UNITED STATES PATENT AND TRADEMARK OFFICE

APPLICATION NO.	FILING DATE	FIRST NAMED INVENTOR	ATTORNEY DOCKET NO.	CONFIRMATION NO.
10/777,190	02/13/2004	Hisayuki Shinohara	900-492	8939
23117	7590	06/30/2006	EXAMINER	
NIXON & VANDERHYE, PC 901 NORTH GLEBE ROAD, 11TH FLOOR ARLINGTON, VA 22203			LANE, JEFFREY D	
			ART UNIT	PAPER NUMBER
			2828

Office Action Summary

DETAILED ACTION

FIG. 24

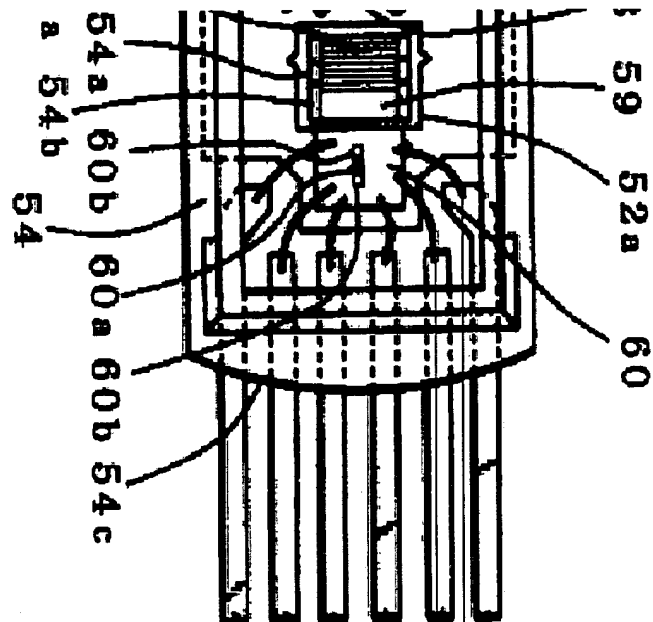
15. As for "the out lead portions of the leads being arranged at greater intervals than the inner lead portions of the leads." When the leads are viewed from their starting locations (inner portion) would have a smaller interval than their ending locations (outer portion). Therefore the limitations of the claims are met. Included below is a copy of fig. 24 from Tajiri, marked up to more clearly illustrate the point.

inner
lead portion
interval

outer
lead portion
interval
